INNER WEST COUNCIL

DEVELOPMENT ASSESSMENT REPORT

Application No.	DA201600678.01
Address	2/32-72 Alice Street, Newtown
Proposal	Section 82A review of Determination No. 201600678, dated 19 April 2017, to fit-out and use the premises as a child care centre for 30 children with hours of operation of 7.00am to 6.00pm Mondays to Fridays with associated on and off street car parking
Date of Lodgement	22 May 2017
Applicant	Two Cubed P/L
Owners	Al Maha P/L
Number of Submissions	7 submissions
Value of works	\$540,000
Reason for determination at Planning Panel	Outside officer delegation as the outcome of the review will involve no substantial change to the prior determination
Main Issues	Urban Design; Site Suitability; Owners Consent; Inadequate Information
Recommendation	Refusal

Image: Location of proposed acoustic walls (indicated in Orange)

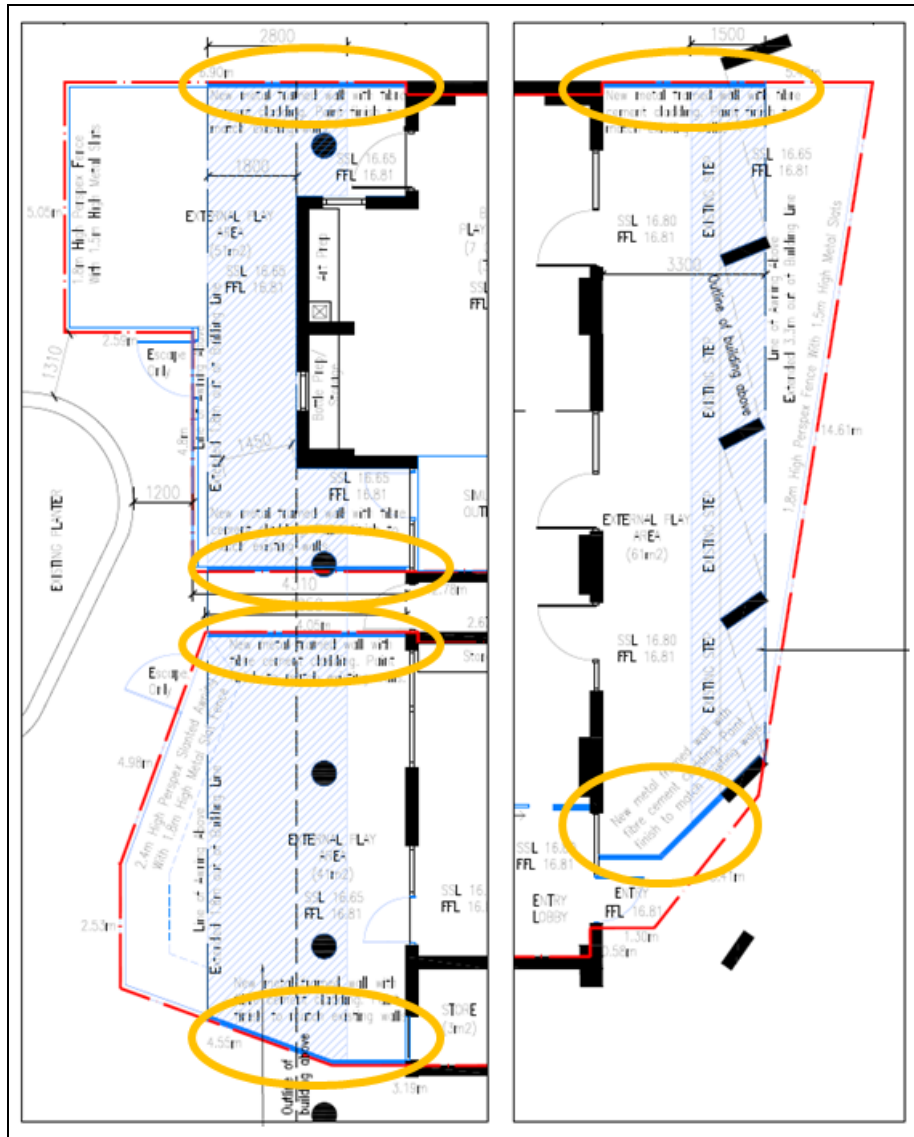
Furthermore, the proposal requires the provision of 6 separate 3.3 metre high metal framed fibre cement cladded walls to comply with the acoustic measures prescribed by the acoustic report submitted with the proposal. The location of these walls is illustrated below;

However, there are no details as how these walls will be constructed without reliance of affixing to the underside of the adjoining balconies above and how they do not extend beyond the subject stratum. Overall the plans lack sufficient detail and the applicant has not submitted the registered stratum plan as requested and the modifications that have been made do not demonstrate the issue of the owners’ consent has been addressed.
